Subject: Airport Plaza Shopping Center
CRWQCB Letter dated August 16, 1995
Workplan Resubmittal
CRWQCB File No. 01-0413 (ES)

Please find enclosed our revised remedial action workplan for the above referenced property dated August 28, 1995. This is the second formal revision for this workplan that we have submitted to your office. This workplan reflects the changes requested by your office in your letter dated August 16, 1995.

**100% SUBMITTAL
REMEDIAL ACTION WORKPLAN
FOR
THE INVESTIGATION AND REMEDIATION OF
VOLATILE ORGANIC COMPOUNDS (VOC'S)
FOUND IN GROUNDWATER
AT
AIRPORT PLAZA SHOPPING CENTER
N/W CORNER OF HESPERIAN AND W. WINTON
23958 HESPERIAN BOULEVARD
HAYWARD, CALIFORNIA
CRWQCB FILE 01-0413 (ES)**

TITLE SHEET

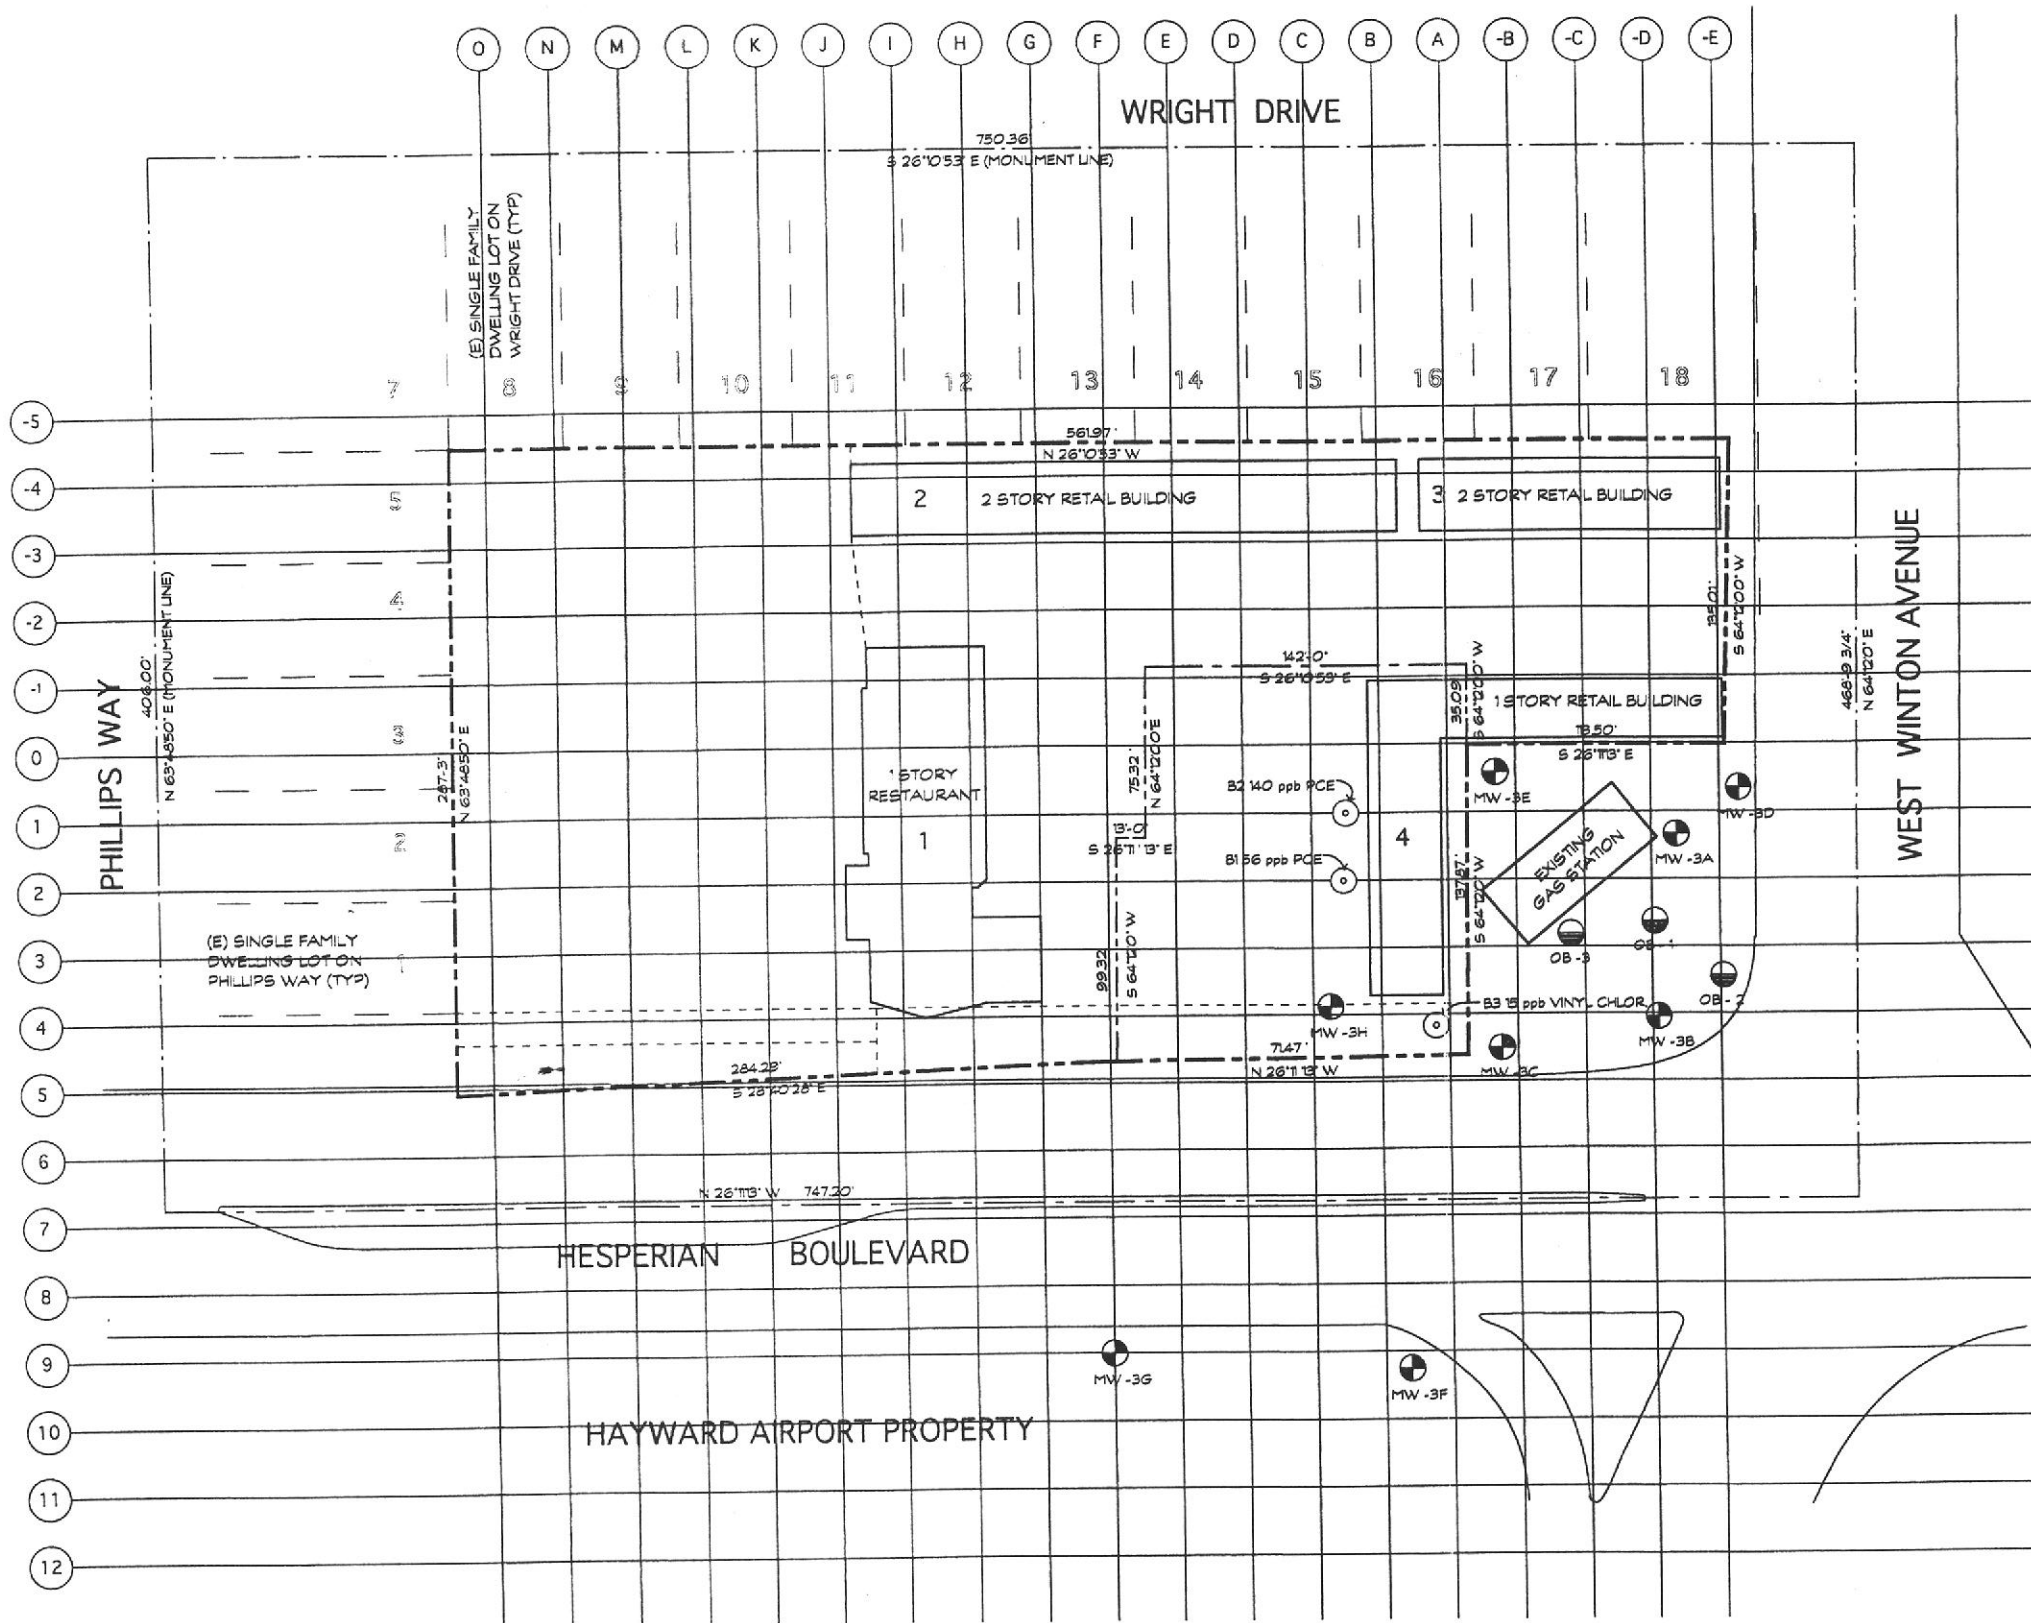
A Health and Safety Plan is required for workplan approval. Also all submitted maps shall contain a legend and numbering system for well, boring, and hydropunch locations.

Response: As indicated by Eddy So, the Health & Safety Plan will be submitted prior to work onsite. The well/boring numbering system will be the grid coordinate system found on sheet A2 of the drawings. As indicated on drawing sheet A1, the symbols legend describes the coordinates/grid system. We will preface our wells and borings by the initials "VBA" to distinguish between our wells and others onsite that have been assigned identification numbers that may be similar to our scheme.
